CHAMPIONS QUARRY Minor Operational Changes Modification (PA 09_0080 MOD 2)

Environmental Assessment Report Section 75W of the *Environmental Planning and Assessment Act 1979*

Figure 2: Location of Internal Haul Road

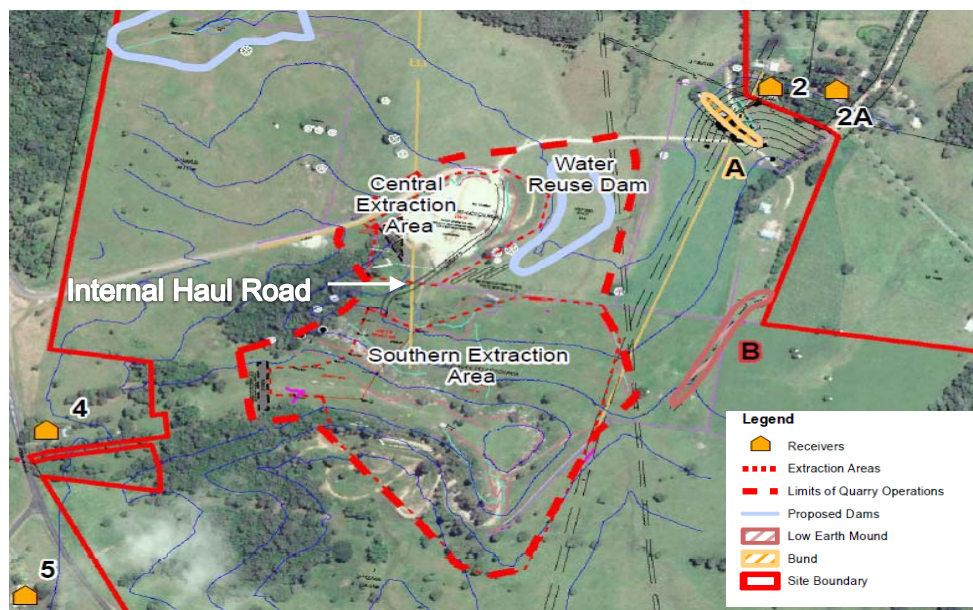
The sealing of the internal haul road between the Central and Southern Extraction Areas was proposed as part of the dust control measures contained in the 2009 project application and EA. Champions has stated that sealing the haul road is impractical as heavy machinery would rip up the seal, resulting in potential contamination of product, and has requested that watering the haul road be allowed as an alternative.

As noted in correspondence dated 13 January 2015 from the Department to Champions Quarry, the Department has previously accepted that sealing the internal haul road would be of little benefit and would likely be damaged by heavy vehicles. The key issue is whether the sealing of the internal haul road is necessary for the quarry to meet air quality criteria and whether watering of the haul road is a satisfactory alternative. As identified in the 2009 EA (see Table C1: Emissions Estimation in the Air Quality Assessment (ERM, November 2009)), the air quality modelling assumed that internal haulage would be on unsealed roads. There were also a number of other factors which led to the model and its predictions being conservative. Nonetheless, the Air Quality Assessment predicted that the quarry could meet all air quality criteria at all private residences. Champions is currently complying with air quality criteria, as detailed in its 2015 and 2016 Annual Reviews.

The Department considers that watering of internal haul roads at a rate of 2 litres per m² per minute is an acceptable method of controlling dust from haul roads. The Department is satisfied that watering the internal haul road between the Central and Southern Extraction Areas as an alternative to sealing the road is a satisfactory and practical method of controlling dust.

**Figure 3: Approved Conceptual Biodiversity Offset Areas and Protected Revegetation Areas**

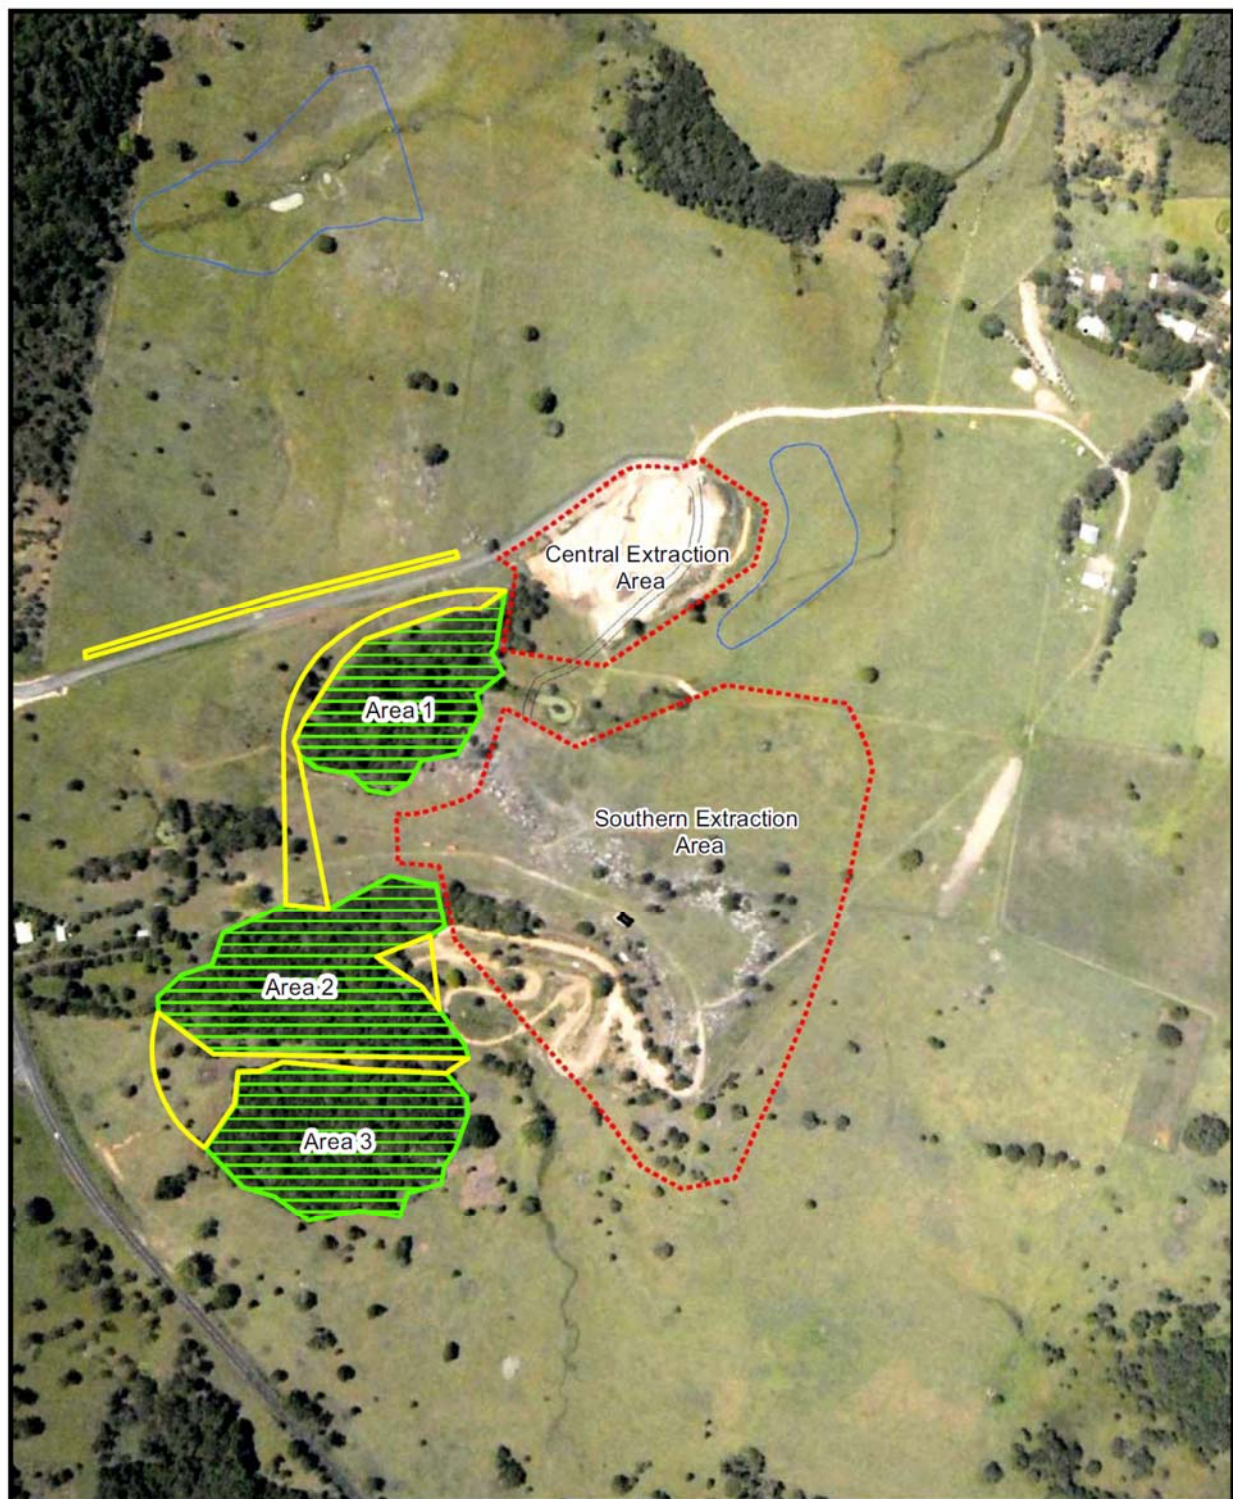
However, in reviewing the revised boundaries overlaid on the aerial photo (see **Figure 3**), it can be seen that Champion's revised boundaries would result in less high density/quality vegetation and a greater area of lower density vegetation in the proposed Biodiversity Areas 1, 2 and 3. Conversely, the proposed Protected Revegetation Area would contain high density/quality vegetation and less low density vegetation. This is contrary to the intent of the offset areas and is inconsistent with Champions' claim that the revised boundaries are in part the result of ground-truthing current vegetation.
